REQUEST FOR PROPOSAL | HDMD / RFP- 230502
Lighting Designer as Consultant for the
Downtown Houston Pedestrian Lighting Framework for the
The Houston Downtown Management District

Addendum 01

ADDENDUM 01 ISSUE DATE: Wednesday, April 26, 2023

Placer.ai Example

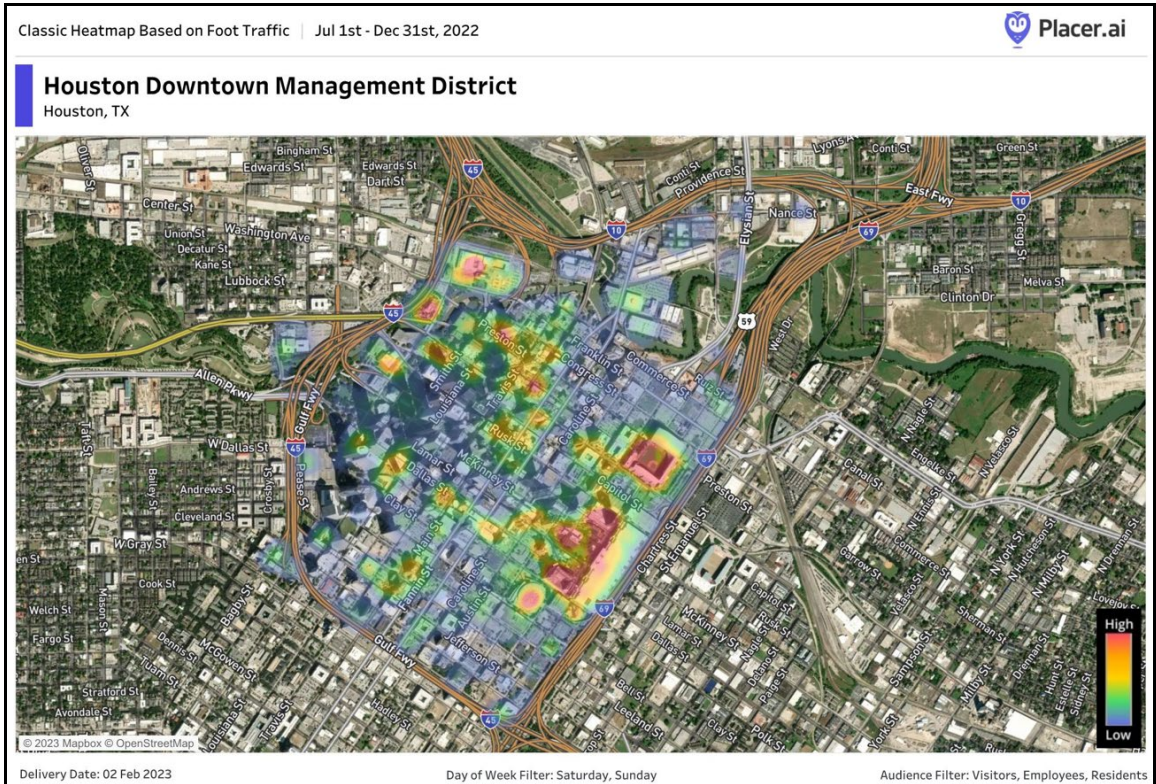
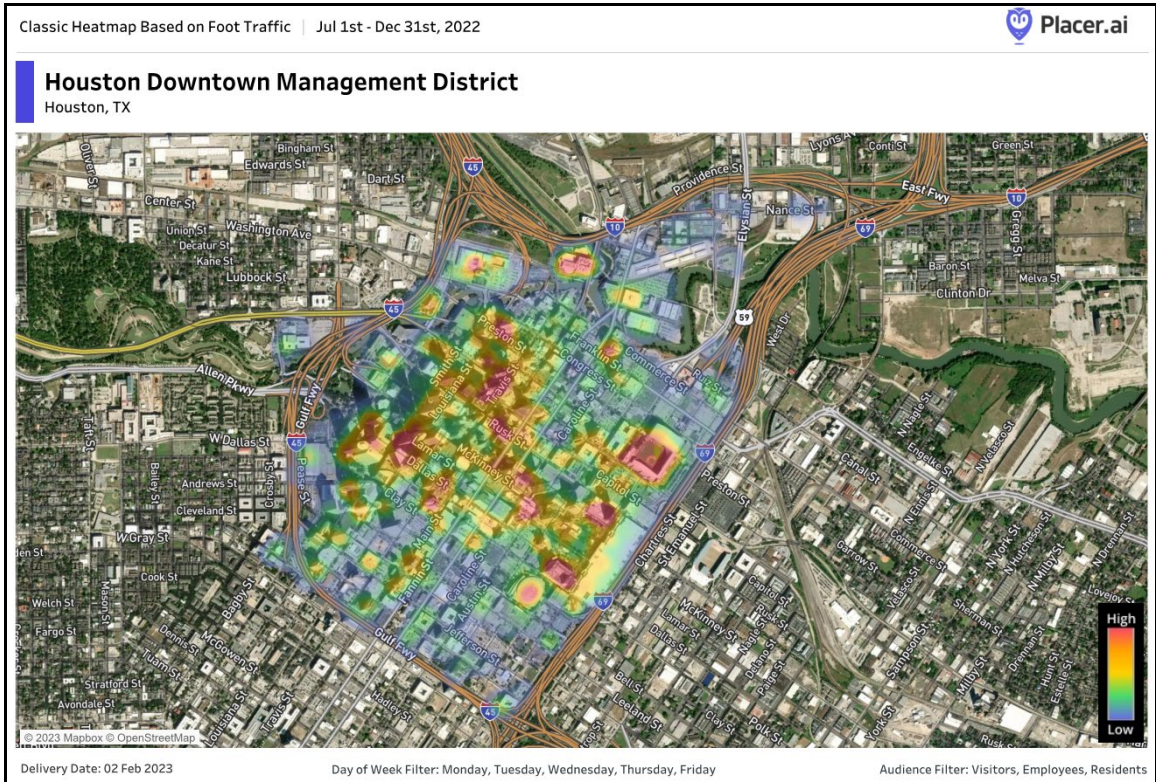
Q17: Could you provide us with a graphic example of the data we could expect to receive from Placer.ai?

A: See attached examples, indicating weekday and weekend pedestrian activity for July 1 – December 1, 2022, within the HDMD boundaries.
